Wester-Wetstein & Associates, Inc.

October 5, 2015

Re: Site Specific Investigation
East Grand Avenue Property
Technical Review

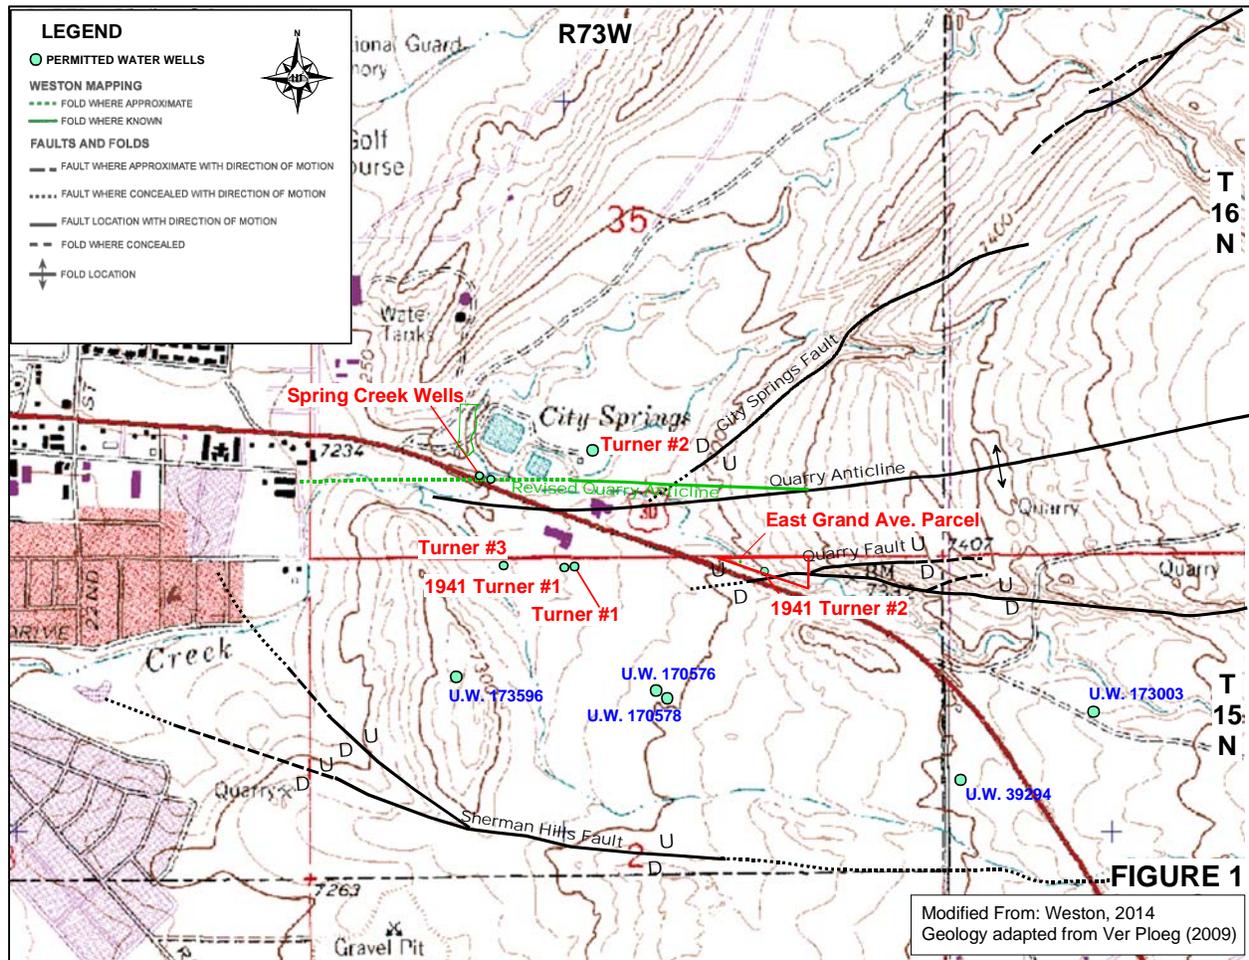
One item that was researched and discussed in later sections of Trihydro's SSI, but not listed in this section of their report, were the State Engineer's Office completion records for the wells in the subject property area. A review of the statement of completion records for the wells in the area indicated that three of these wells referenced either encountering fractures or losing circulation of the drilling fluid during the drilling phase. These wells are the two Wyoming State Highway Department wells (Spring Creek Well Nos. 1 and 2) located approximately ¼ mile west of the East Grand Avenue Parcel and the Bone and Joint #1 Well (U.W. 39294) located approximately ¼ mile south of the East Grand Avenue Parcel. The driller of the Spring Creek wells documented encountering "fractured zones" at depths below approximately 20 feet. The

driller of the Bone and Joint well indicated that circulation was lost during drilling from 36 feet below ground level to the well's total depth at 140 feet. Reference to fracture zones and lost circulation in the nearby wells is evidence that conduit flow could be present in the area of the East Grand Avenue Property parcel although no fractures were recorded as being encountered in the 1941 Turner #2 Well which is located within the parcel boundaries. The locations of the Spring Creek wells and Bone and Joint well are shown in the figure below.

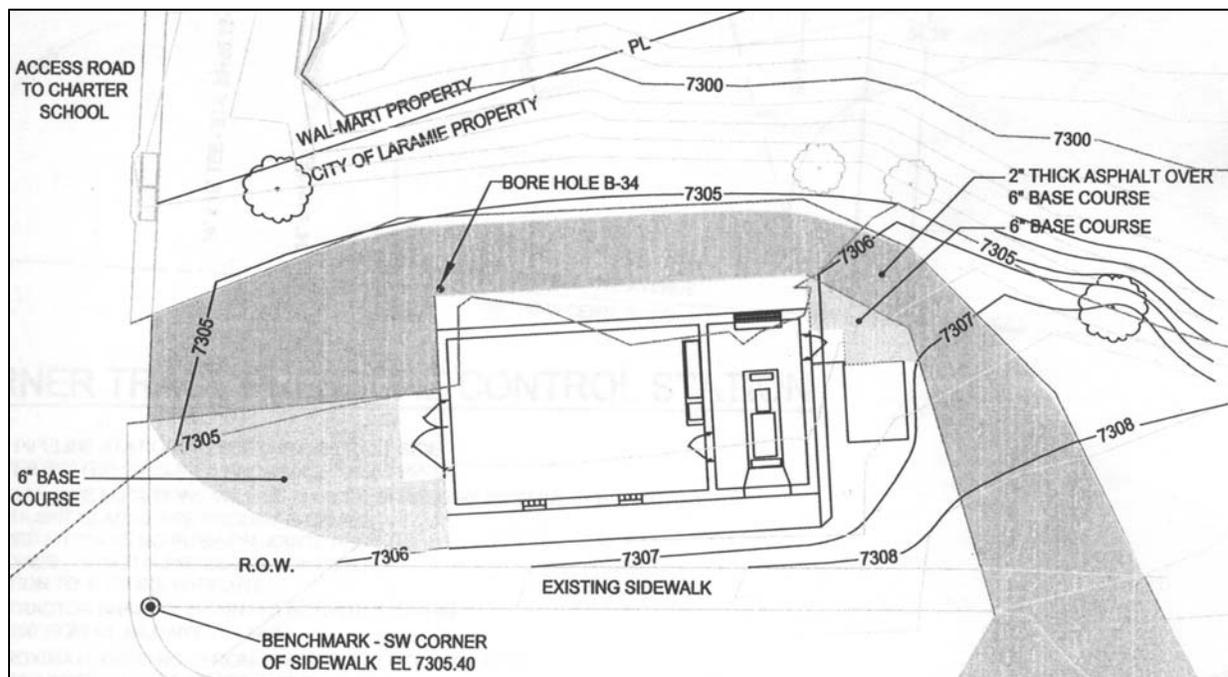
The SSI prepared by Trihydro does not address this section. A preliminary site plan was not presented by Trihydro as they state "A preliminary site plan for development is not presented as the City has no plans to develop this property at this time." The SSI report did present a surface geology map that has the Laramie USGS 7.5 Minute topographic map as a background (Figure 1). However, the scale of this map did not accurately reflect the topography (scale of map was too large to show adequate number of contours and the contour labeling). The SSI report also incorporates an aerial photograph as a background (Appendix B) which shows the existing land use in the area. The figure on the preceding page of this review letter report shows the topographic conditions for the East Grand Avenue Property. The contour interval for this figure is 10 feet. The site map for the construction of the Imperial Heights Pump Station showing the finished surface elevations is shown on the following page.

In general we agree with the concept presented in the SSI report that this section cannot be fully addressed at this time due to the status of the development plans for this parcel of land. However, we feel it would be beneficial to the City to include some of the requested information such as a topographic map, a discussion of the existing land use practices in the area and some general discussion with respect to development constraints or issues associated with this parcel of land due to its proximity to the vulnerable features identified in paragraph 15.08.040.A.8(d)(i).

The requirements of this section were met by the Trihydro SSI. A field inspection was conducted on April 29, 2015 and the wells on the property were identified in the text and in Figure 1 of the report. This figure provides the requested distance and direction information of the wells. As discussed under the 15.08.040.A.8(d)(i) section, two vulnerable features, Quarry anticline and an unnamed ephemeral drainage, were identified in the East Grand Avenue Property area. The 100 foot setback distance from these two vulnerable features incorporates nearly this entire parcel of land. The SSI prepared by Trihydro presents a map (Figure 1) which identifies the location of only the Quarry fault. The location of the other vulnerable feature, unnamed drainage, is discussed in the text of the SSI report but is not called out in this figure. The drainage is shown more clearly in the figure in Appendix B of the SSI report, but is again not labeled. No evidence of fracturing was noted in the unnamed drainage and no spring flow is present. During the design and construction of the Imperial Heights Pump Station, no groundwater was encountered in the initial 20 feet of soil at the pump station site (Soil Boring B-34 – location shown in figure on previous page).
